Road Safety Audit Report

**Incorporating
Stage 1 Completion of Preliminary Design;
Design Organisation Response to items raised; and
Auditors View of Design Organisation Response.**

Proposed priority access to land adjacent to No.54 Long Copse Lane Emsworth

Job no	RSA-20-135	Issue no	4	Date	December 2020
Prepared by	JJF	Verified by	FB	Approved by	JJF
Filename and Path	Fenley/Road Safety Audits/RSA-20/RSA-20-135-4

Item Location Plan

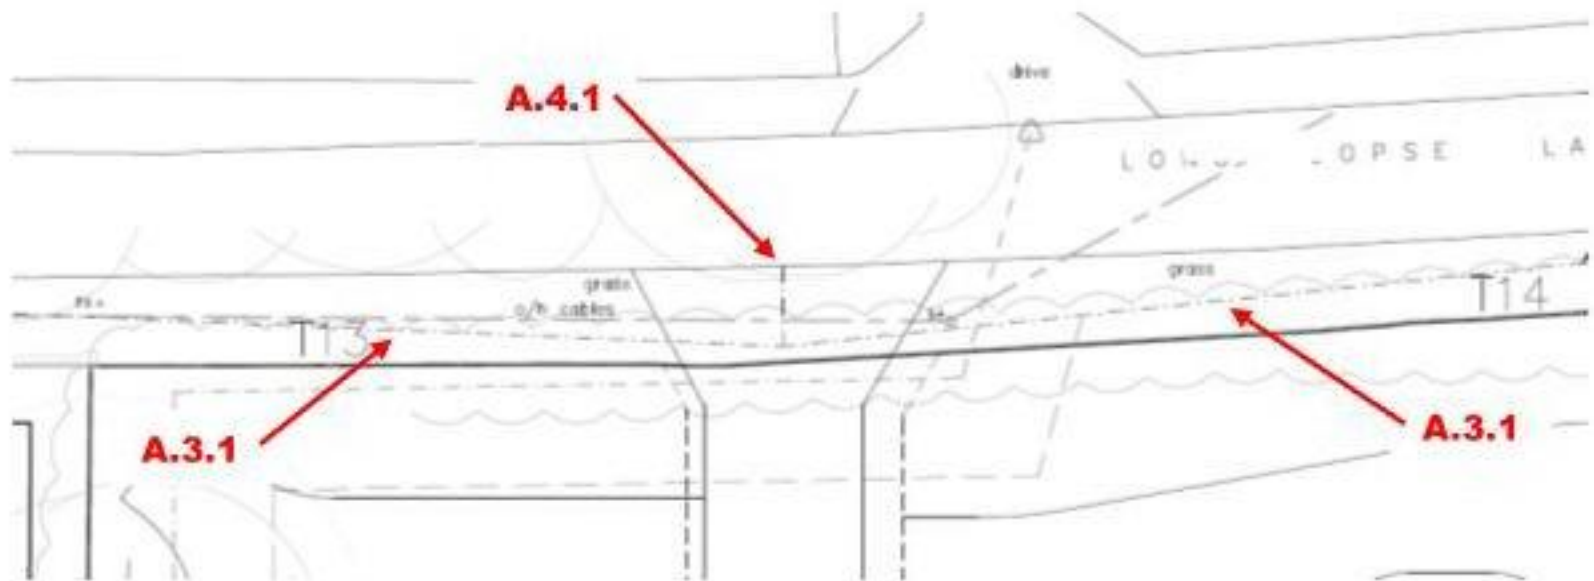
A.1	LOCAL ALIGNMENT
	<i>No Road Safety Concerns regarding LOCAL ALIGNMENT have been raised at this stage</i>
A.2	GENERAL
	<i>No Road Safety Concerns in GENERAL have been raised at this stage</i>
A.3	JUNCTIONS
A.3.1	PROBLEM
Location:	Site Access
Summary:	Vegetation along the frontage could restrict visibility
Acc Type:	Side and rear impact collisions
The Long Copse Lane frontage of the application site currently consists of a hedgerow/vegetation that encroaches the grass verge that is present beyond full height kerbs alongside the carriageway. The proposals are to provide a priority access that is to serve a shared driveway accommodating 8 dwellings. The scheme drawing provided with the Audit Brief, identifies that a visibility splay of 2.4x49 metres is achievable to the right (east) and 2.4x47 metres is achievable to the left (west) which accord with the stopping sight distance of approaching vehicles as detailed. No details of the proposed boundary treatment have been provided at this stage, however, vegetation extending into visibility splays could give rise to vehicle attempting to exit a priority access when it is not safe to do so and side or rear impact collisions.

RECOMMENDATION:	
It is recommended that an appropriate boundary treatment is provided to ensure that the splays illustrated, do not become obstructed.	
Location Plan: 	
DESIGN ORGANISATION RESPONSE provided by Nick Culhane on the 17 th December 2020 following formal issue of this Stage 1 Road Safety Audit on the 15 th December 2020 The existing vegetation will be cut back or removed to a distance to at least 0.5m behind the proposed visibility splay and therefore maintained in perpetuity to allow for adequate visibility splays to be provided.

AUDITOR'S VIEW OF DESIGN ORGANISATION RESPONSE dated 17th December 2020	
Confirmation that the splays will be maintained clear at all times, addresses the road safety concern raised at this stage.	
A.4	WALKING, CYCLING AND HORSE RIDING
A.4.1	PROBLEM
Location:	Vehicular crossover
Summary:	Kerbing will be an obstruction to pedestrians
Acc Type:	Trip and fall
Long Copse Lane is a narrow rural road that does not accommodate footways and as such acts as a shared surface carriageway. The proposals provide as priority access off the southern side of Long Copse Lane. The Audit Brief does not provide details of kerbing and as such, the Audit Team are unaware of the transition between the existing carriageway and proposed shared driveway. Kerbing with an upstand in excess of 6mm, will be a trip hazard for pedestrians and troublesome for users of wheeled devices such as wheelchairs, buggies and scooters which could result in a fall.

RECOMMENDATION:	
It is recommended that the transition between the existing carriageway and proposed shared driveway, is smooth	
Location Plan:

DESIGN ORGANISATION RESPONSE provided by Nick Culhane on the 17th December 2020 following formal issue of this Stage 1 Road Safety Audit on the 15th December 2020	
It is not proposed to provide a kerb delineation between the existing carriageway and the proposed site access. The existing macadam surface will cut and a level transition of new macadam roadway will be installed at the same level of the existing carriageway.	
AUDITOR'S VIEW OF DESIGN ORGANISATION RESPONSE dated 17th December 2020	
Confirmation that no kerbing is to be provided which will ensure a level transition and addresses the road safety concern raised at this stage.	
A.5	ROAD SIGNS, CARRIAGEWAY MARKINGS AND LIGHTING
	No Road Safety Concerns regarding ROAD SIGNS, CARRIAGEWAY MARKINGS AND LIGHTING have been raised at this stage
